GE Energy

MFN 06-264

Subject: Response to Portion of NRC Request for Additional Information Letter No. 18 Related to ESBWR Design Certification Application - Containment Design - RAI Numbers 6.2-9, 6.2-13, 6.2-32, 6.2-33, 6.2-35 through 6.2-39, and 6.2-41 through 6.2-47

**Response to Portion of NRC Request for
Additional Information Letter No. 18
Related to ESBWR Design Certification Application
Containment Design
RAI Numbers 6.2-9, 6.2-13, 6.2-32, 6.2-33,
6.2-35 through 6.2-39, and 6.2-41 through 6.2-47**

Figure 6.2-18 (continued). RWCU/SDC System Subcompartment Pressurization Analysis (Sub-Model 2)

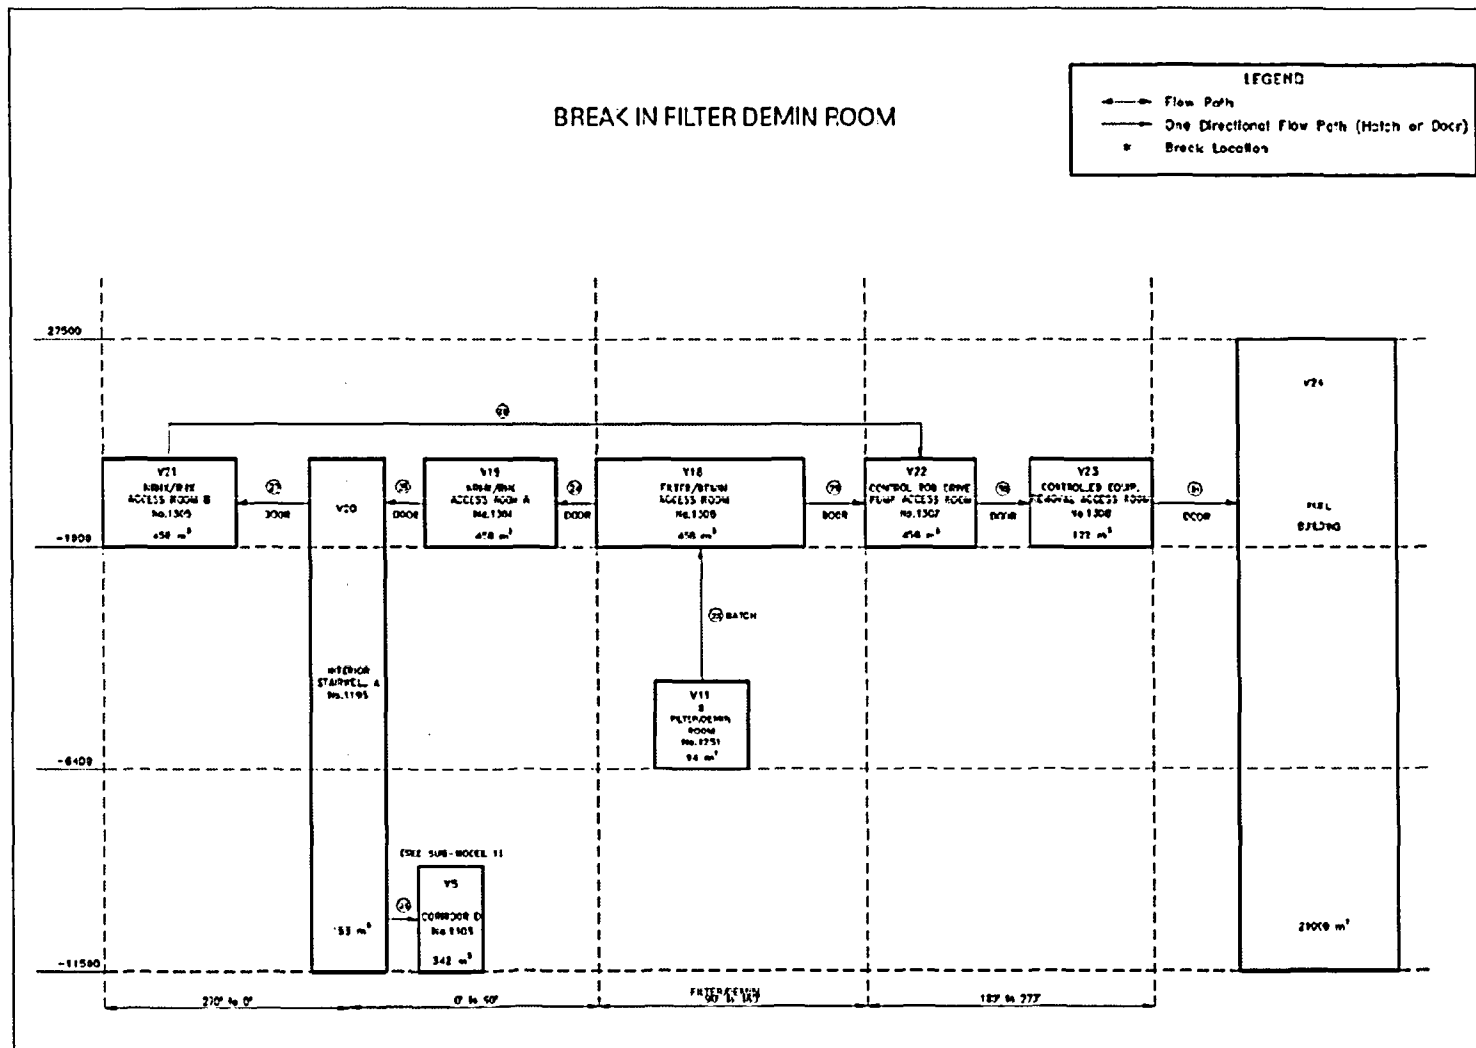
DCD Figure 6.2-18 is called typical. In addition, there is a reference on the figure to a "sub model 2." This models does not appear to be in the DCD, provide it. For each applicable subcompartment, provide figure(s) of the model(s) and the results of the analyses.

The required information will be included.

DCD Figure 6.2-18 will be updated in the next issue as noted in the attached markup.

Figure 6.2-19 Pressure Histories due to Break Case 1 in Cell 1 (Sub-Model 1)

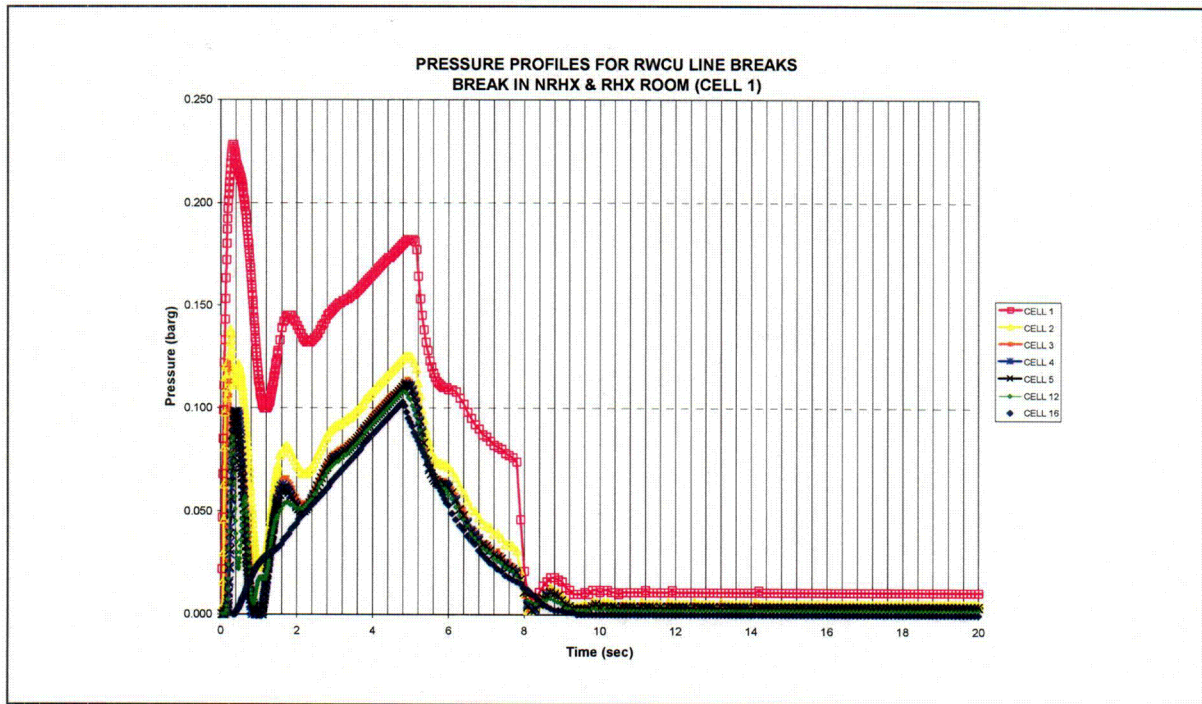
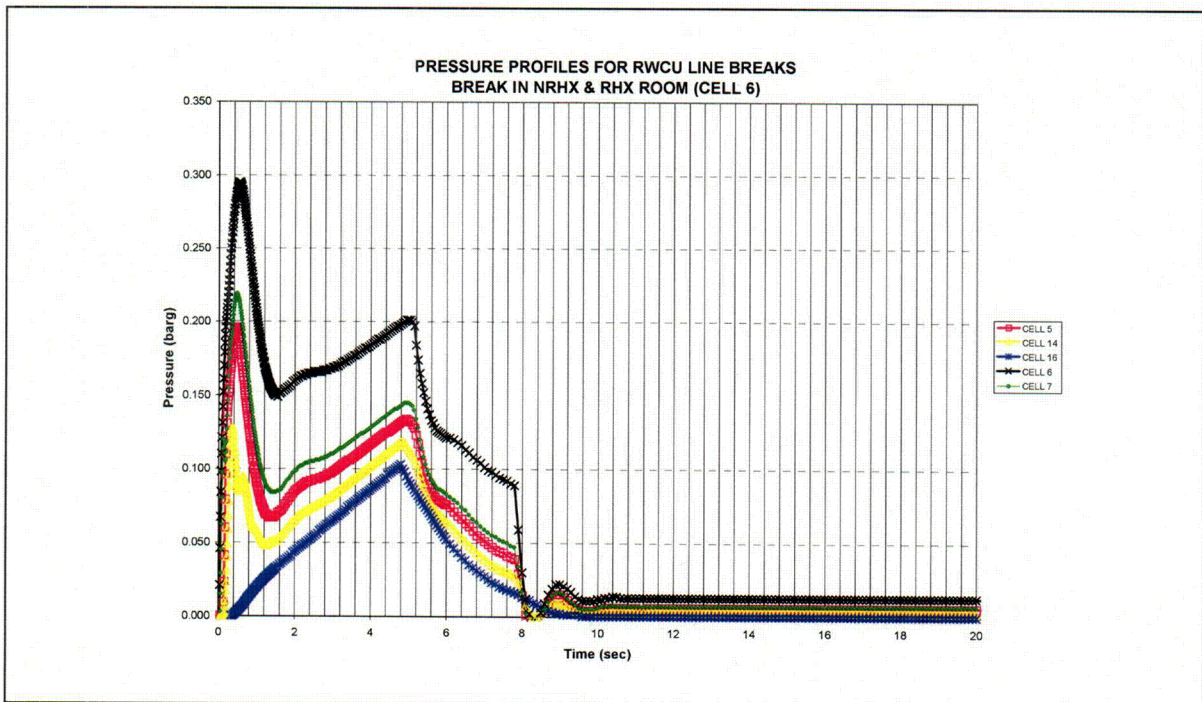
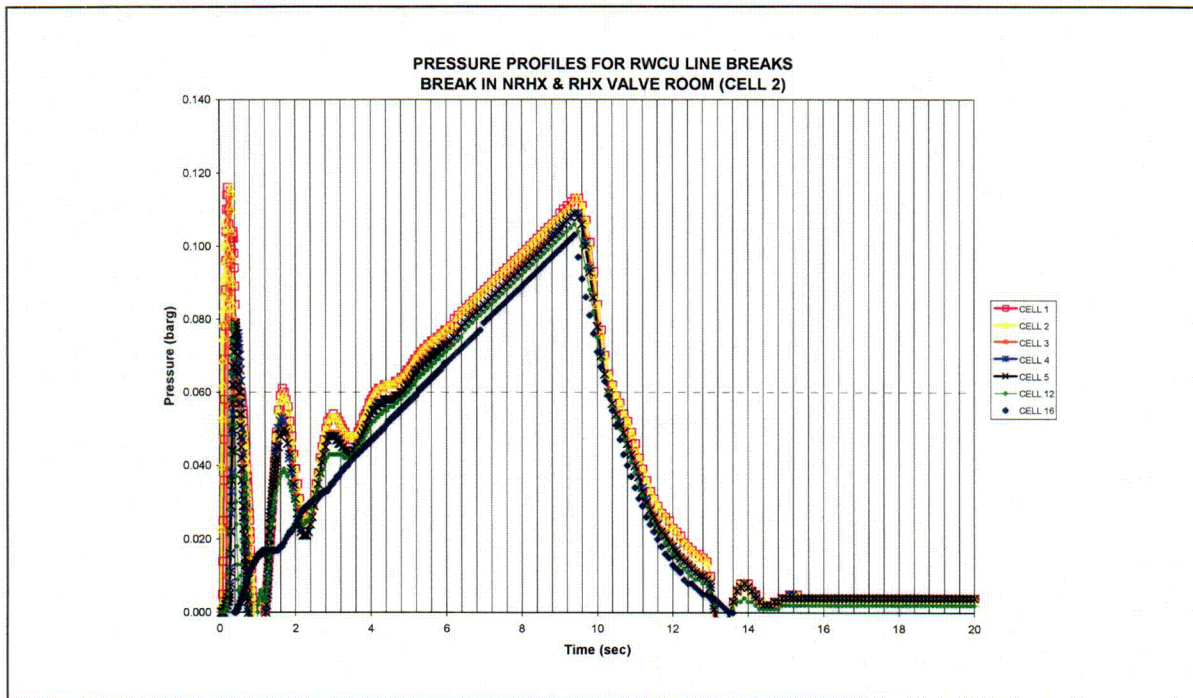
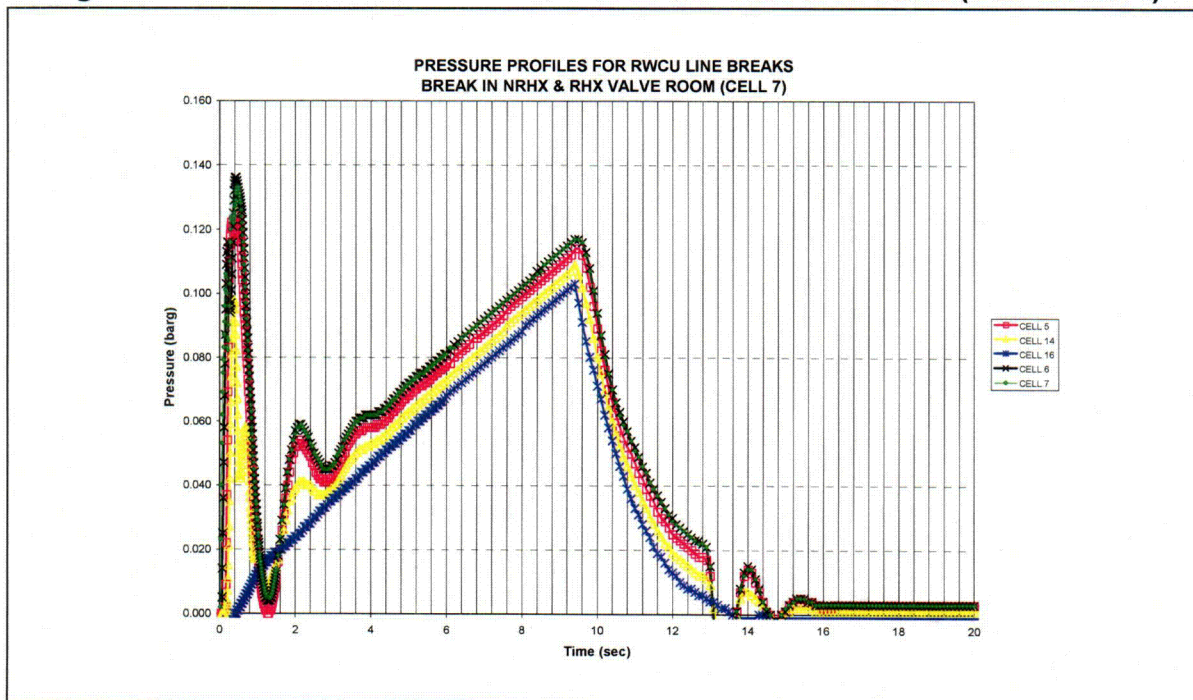
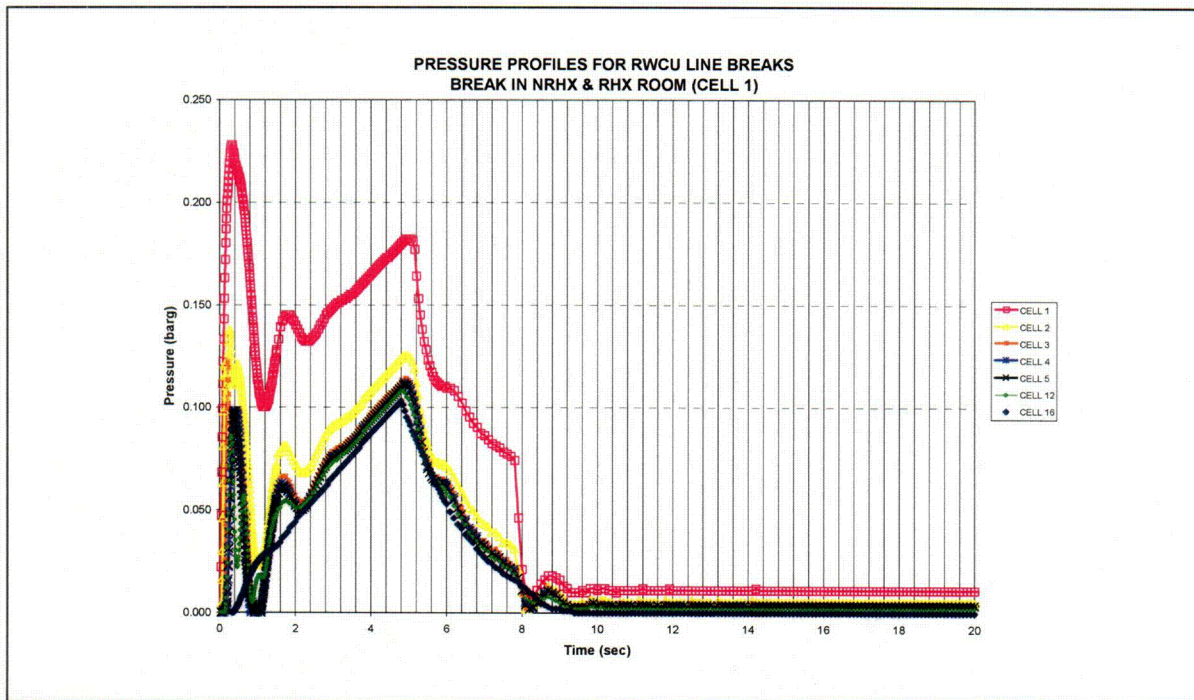
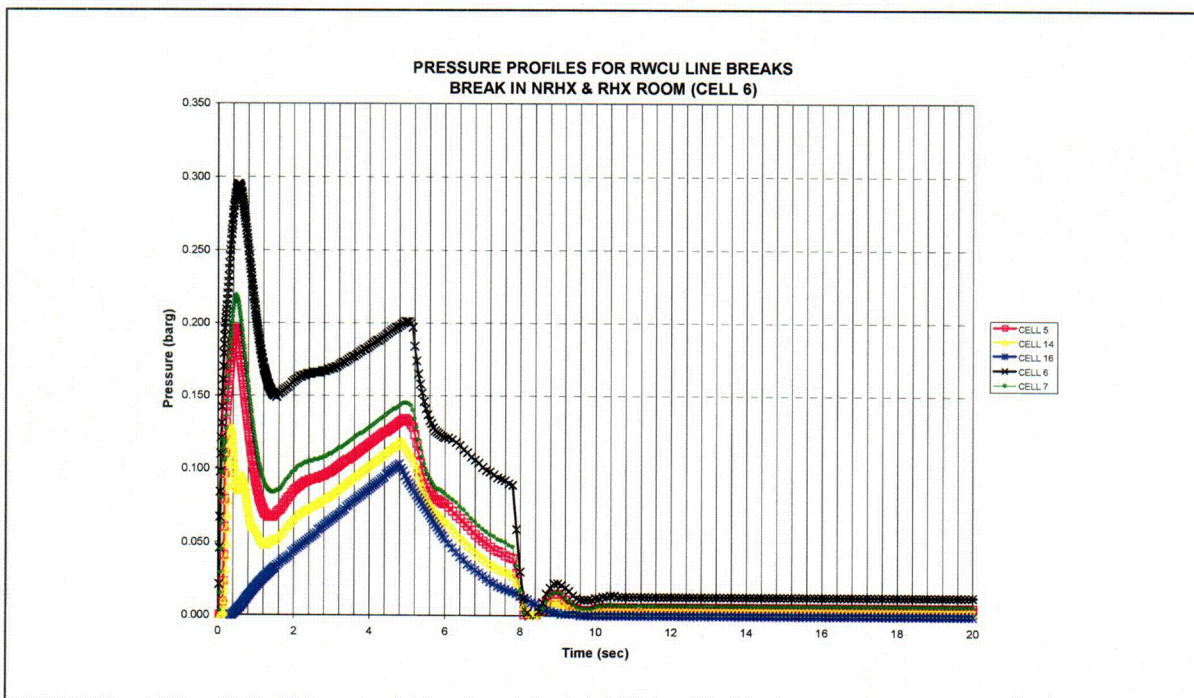
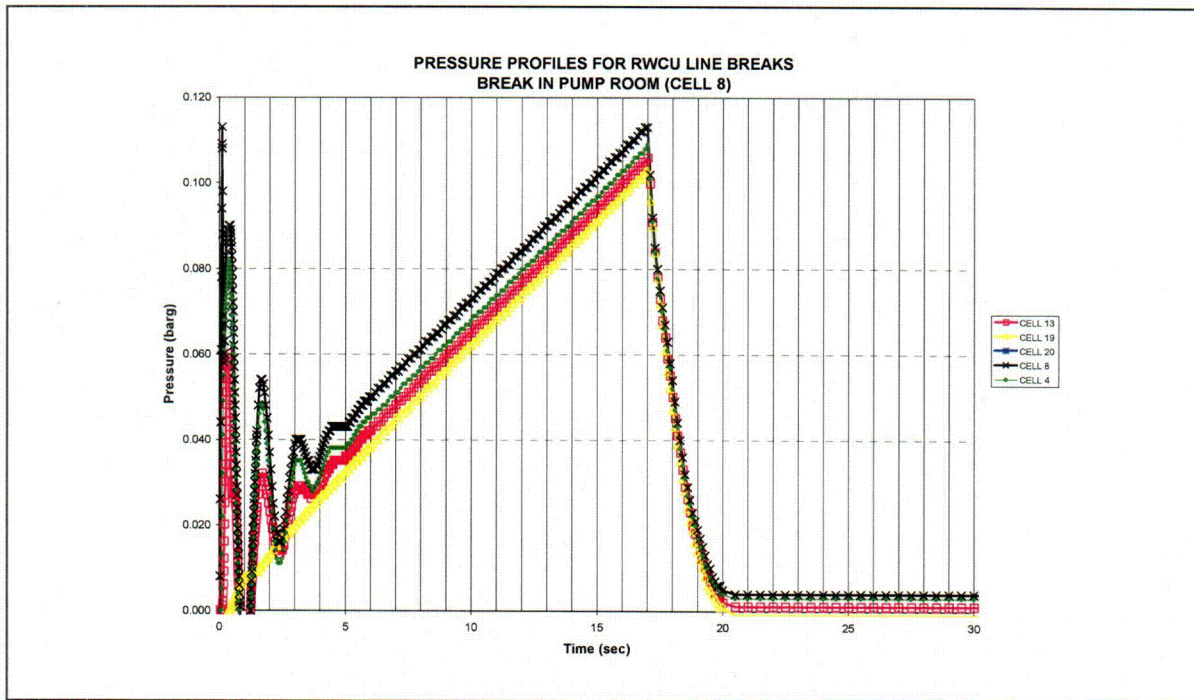
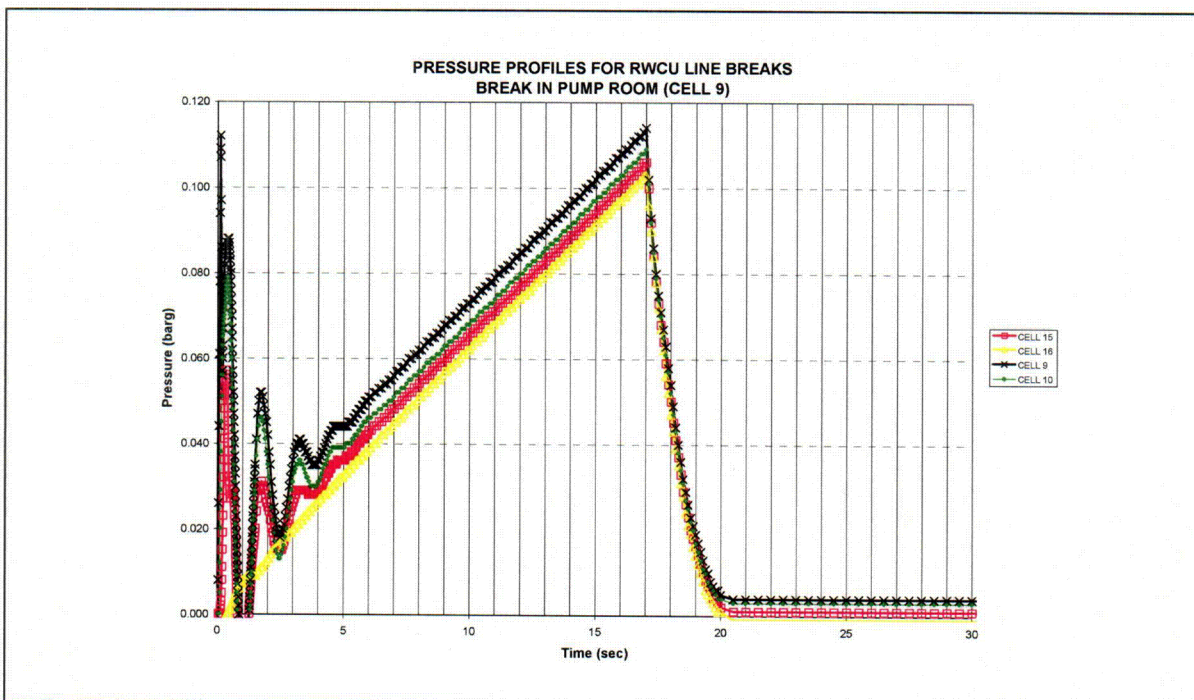
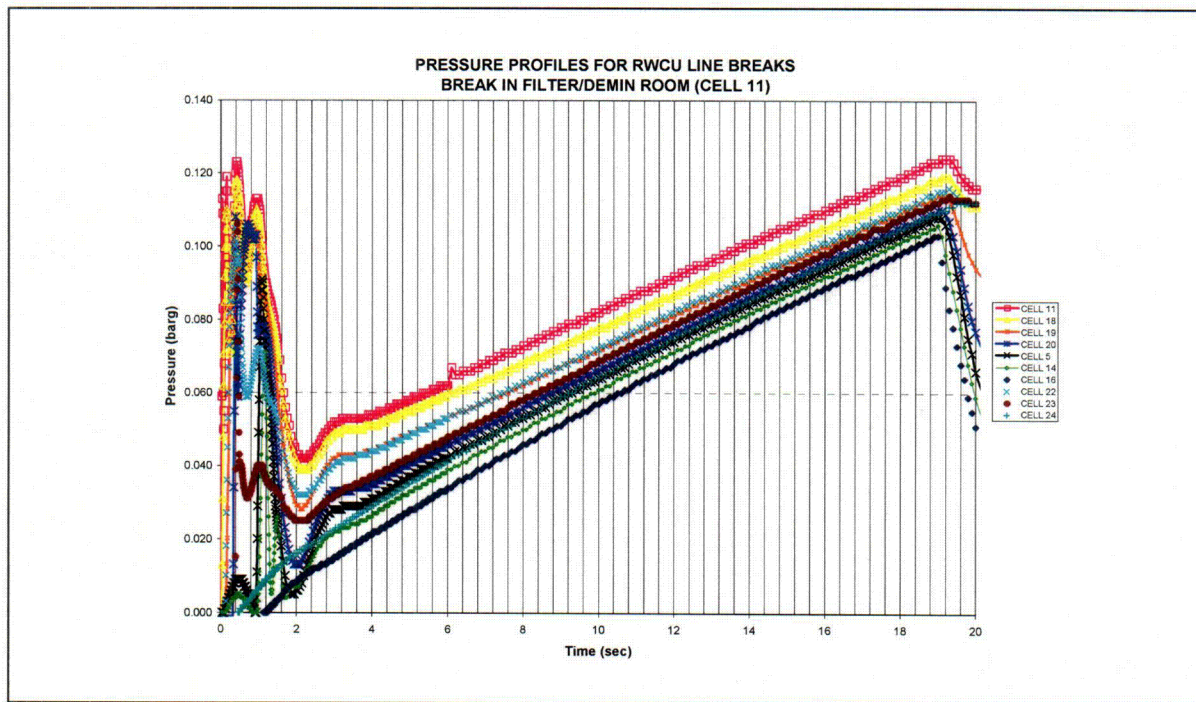
Provide graphs of the pressure responses of all subnodes within a subcompartment as functions of time to permit evaluations of the effect on structures and component supports. Provide this information as part of DCD Tier 2, Section 6.2.1.2.3, "Design Evaluation." This information is necessary to evaluate ESBWR subcompartment loads per SRP 6.2.1.2 and RG 1.70, Section 6.2.1.2..

The required information will be included.

Figures 6.2-19 through 6.2-27 will be added in revision 2 of the DCD.
